FINAL UNEXPLODED ORDNANCE 16 (UXO 16) WIDE AREA ASSESSMENT WORK PLAN  
ATLANTIC FLEET WEAPONS TRAINING AREA FORMER NAVAL AMMUNITION SUPPORT  
DETACHMENT AND FORMER VIEQUES NAVAL TRAINING RANGE VIEQUES ISLAND  
PUERTO RICO  
12/01/2015  
CH2M HILL

**UXO 16 Wide Area Assessment Work Plan  
Atlantic Fleet Weapons Training Area - Vieques  
Former Naval Ammunition Support Detachment and  
Former Vieques Naval Training Range  
Vieques, Puerto Rico**

**Contract Task Order 005**

**December 2015**

Figure 1  
 Available Bathymetric Data Coverage  
 Vieques Puerto Rico

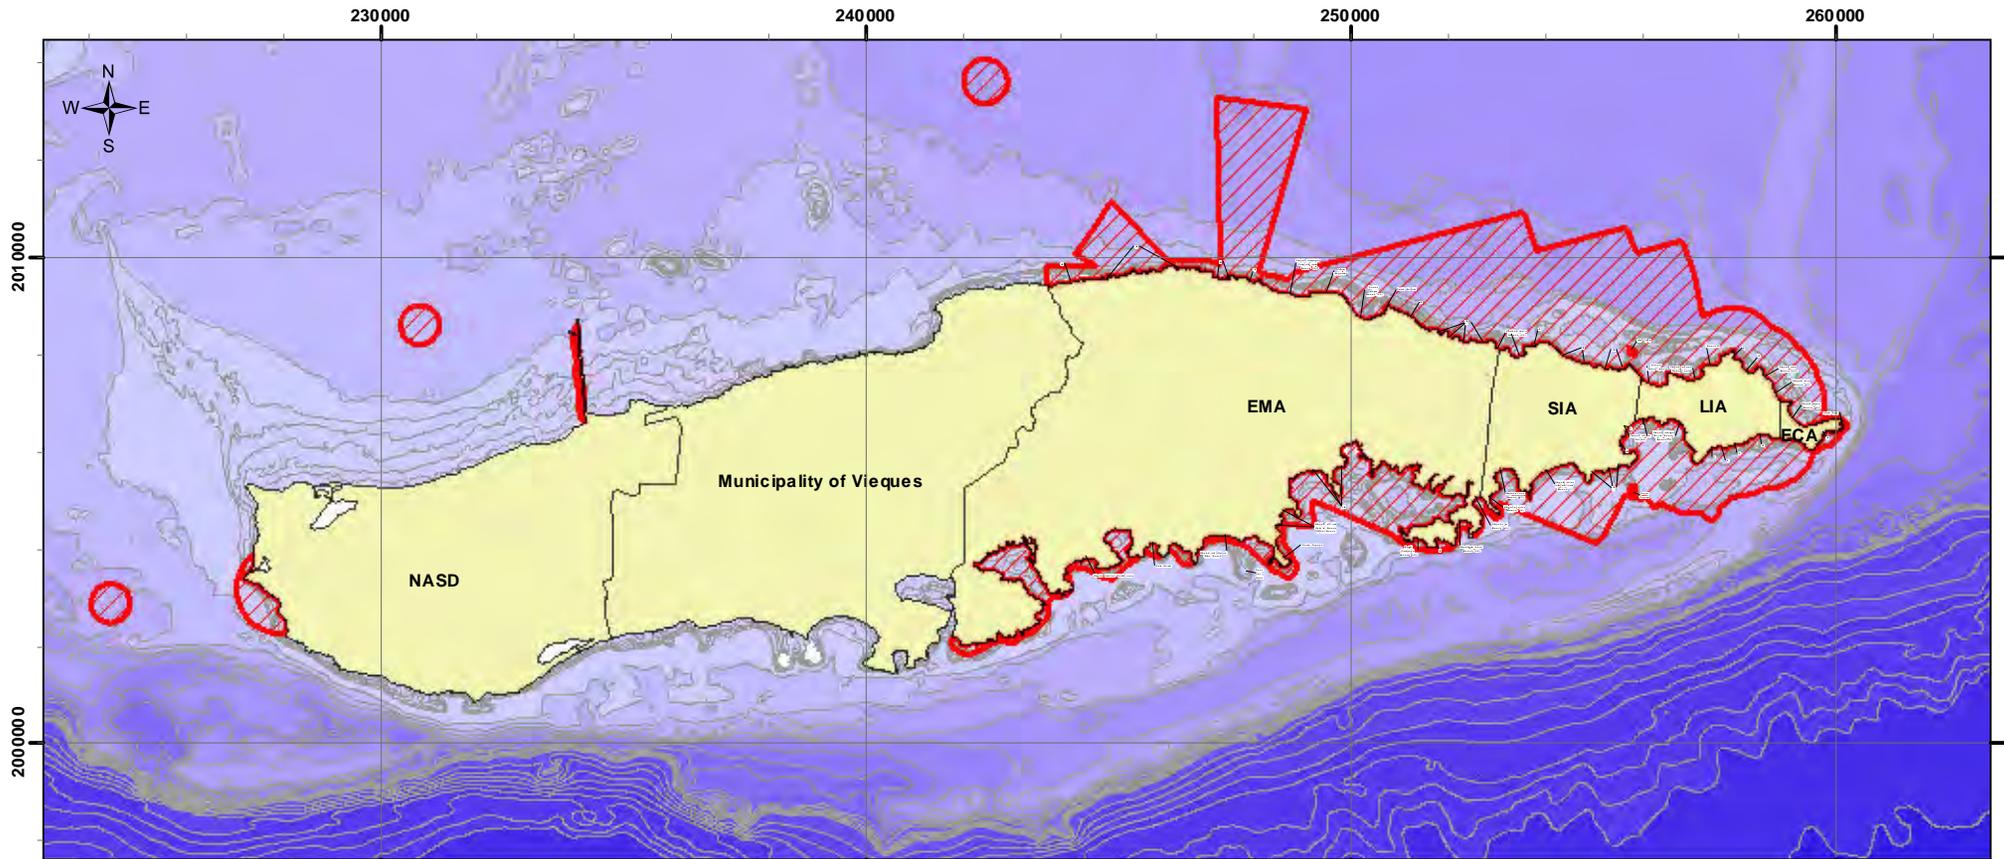
8. **Attachment A, Bathymetry Data Review, Review Findings, Page A-2; Figure 1, Available Bathymetric Data Coverage, Vieques Puerto Rico; and Figure 2, Bathymetric Contours, Vieques Puerto Rico:** The text states that “the Site UXO16 boundary is shown in red on each of the four maps presented as Figure 1,” but the UXO 16 boundary is shown in green on the four maps included on Figure 1. Similarly, the text also states that the UXO 16 boundary is shown in red on Figure 2, but the boundary is also depicted by a green line on this figure. Resolve these discrepancies.

**Navy Response:** Attachment A, Figures 1, 2, and 3 have been modified to show the UXO 16 boundary in red.

**Figure 4**  
**Potential Hazards Identified during Side Scan Sonar Survey**  
Side Scan Sonar Investigation  
Vieques, Puerto Rico

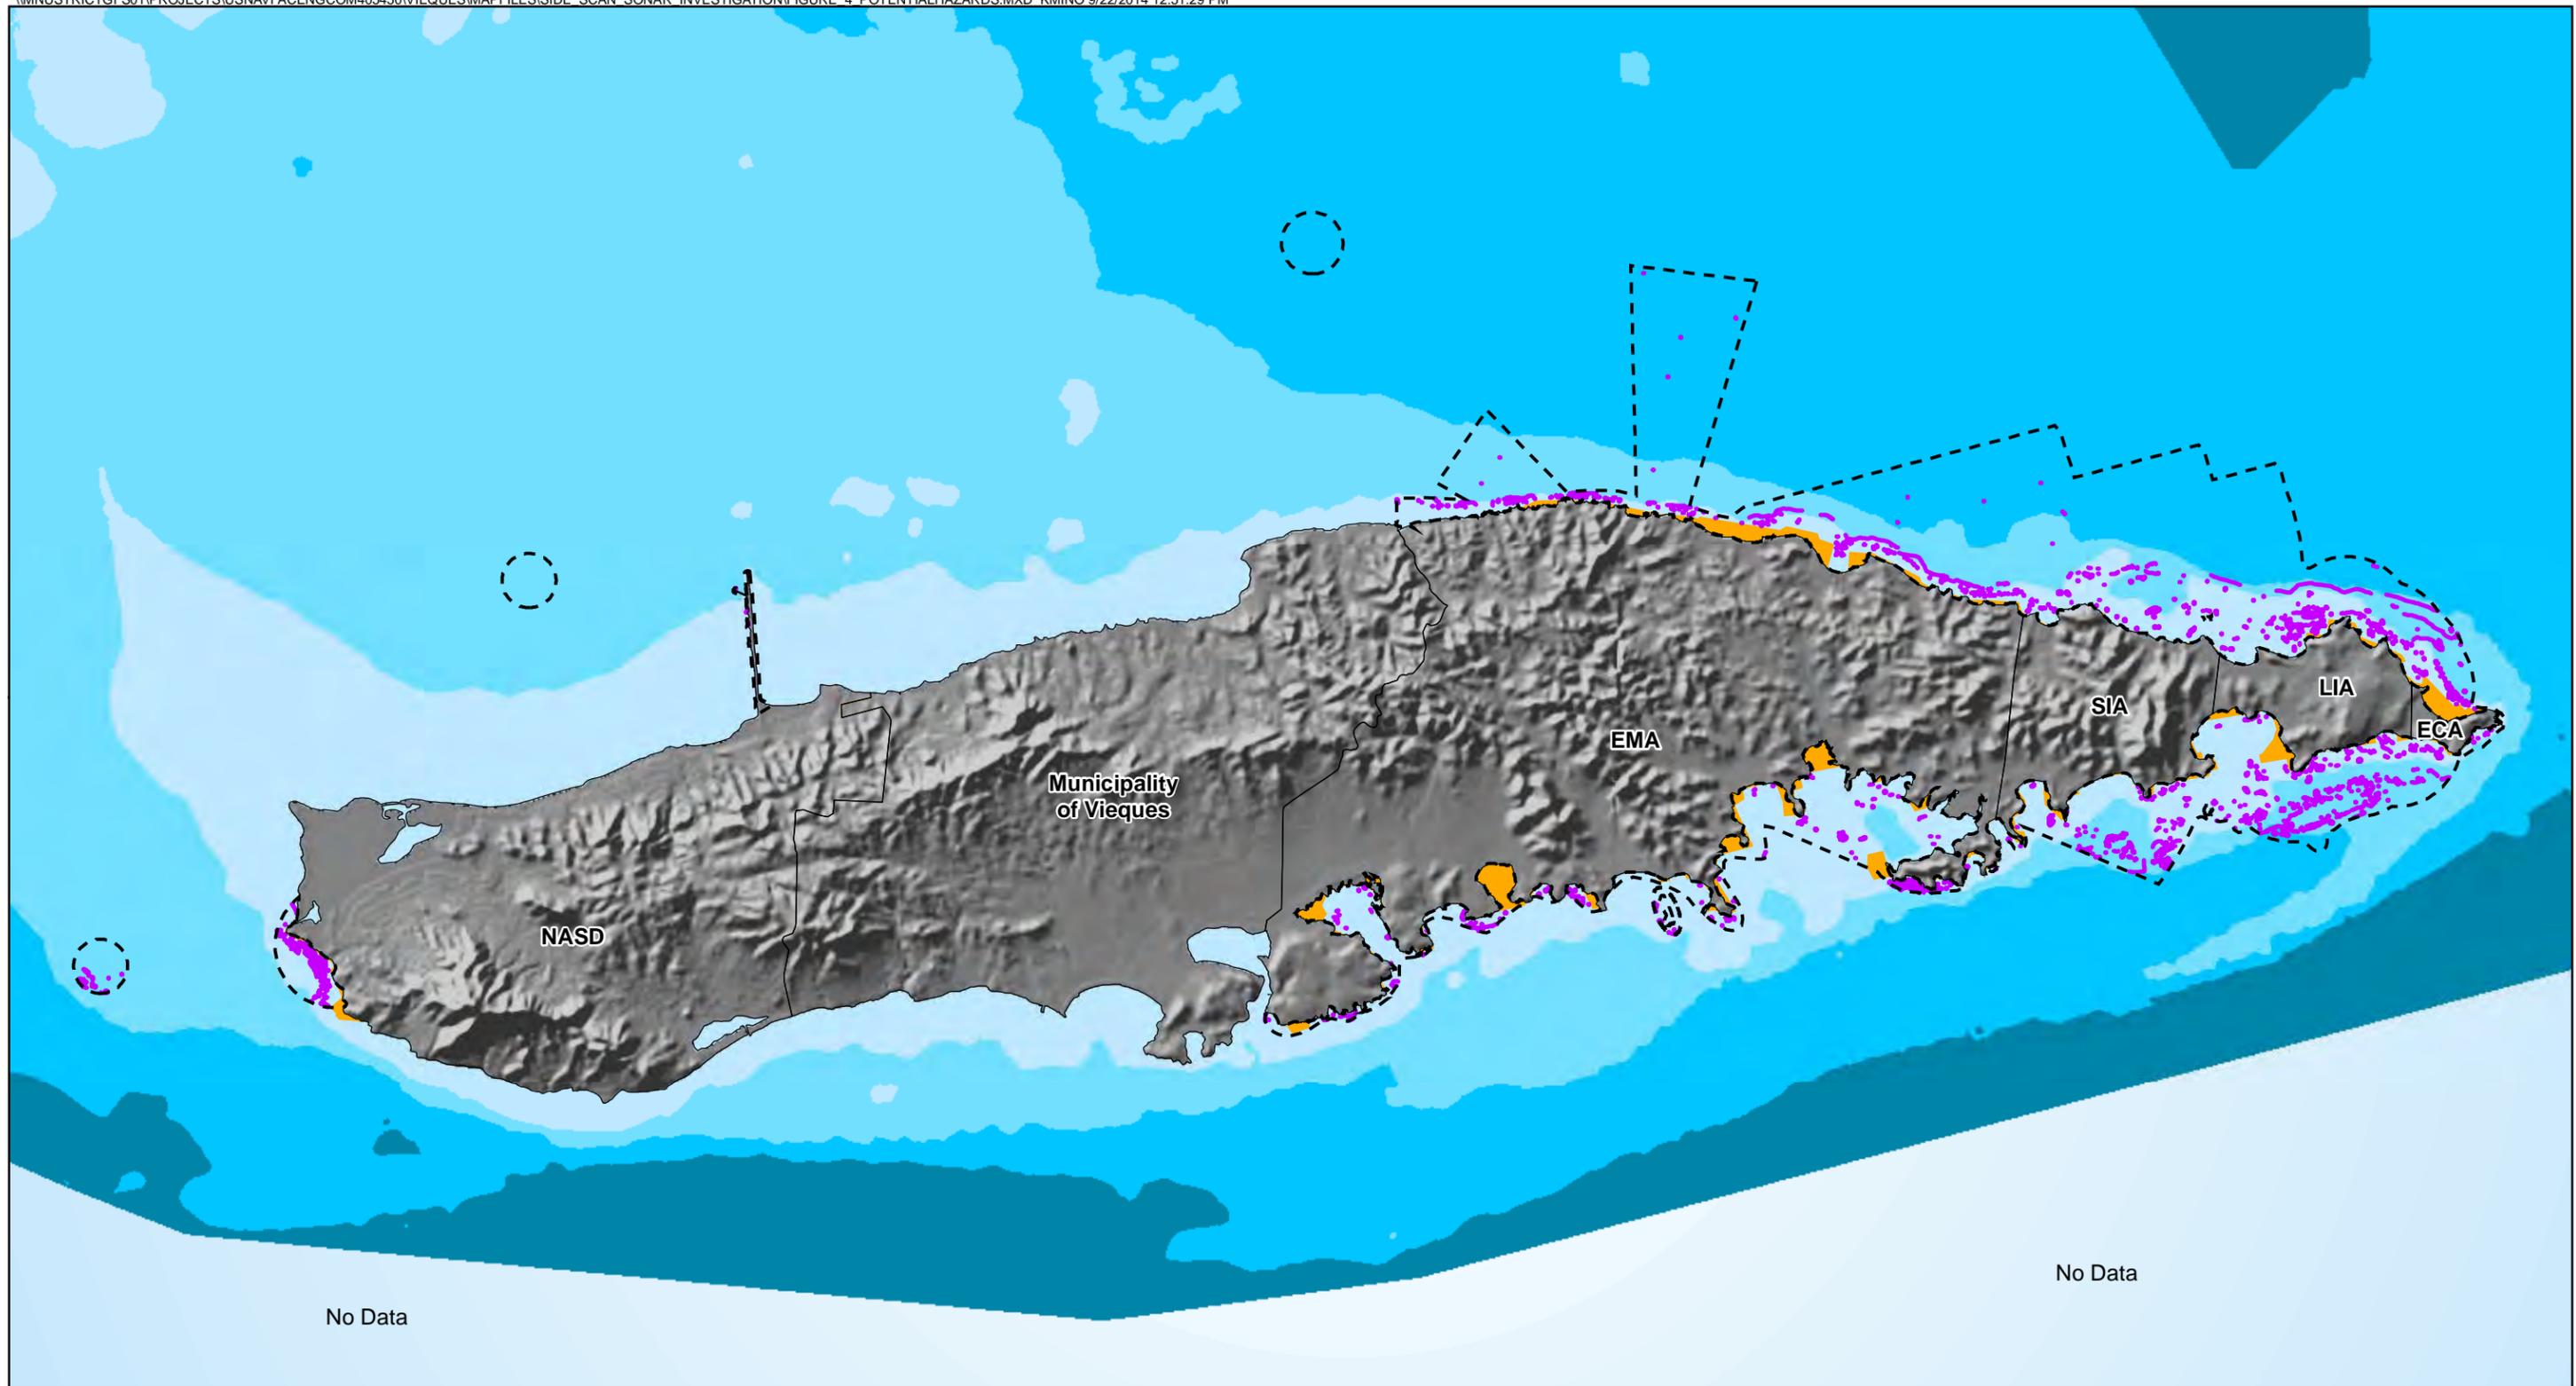
10. **Attachment B, Bathymetry Site Scan Sonar Survey of UXO 16, Summary of Results, Page B-3:** The text states that “targets identifying the 1 meter or greater vertical change on the seafloor for UXO 16 ... are shown in Figure 5,” but Attachment B does not include Figure 5. It appears these features may be shown on Figure 4, Potential Hazards Identified during the Side Scan Sonar Survey. Revise the text to cite Figure 4 or provide the missing Figure 5.

**Navy Response:** The Attachment B text has been modified to refer to “Figure 4” instead of “Figure 5.”
